COMPRESSOR TERMINAL NUT TORQUE

1094 Form 180.23-M2.1

TERMINAL NUT TORQUE

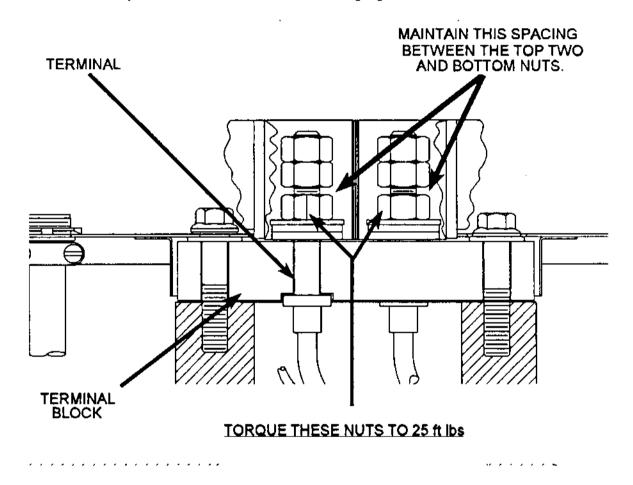
The torque of the nuts that attach the compressor motor lead terminal to the terminal block has been changed. The change affects the current J"F" compressor as well as the upcoming J"G" compressor. The new torque is **25 ft lbs.** See the following figure for the location of the nuts.
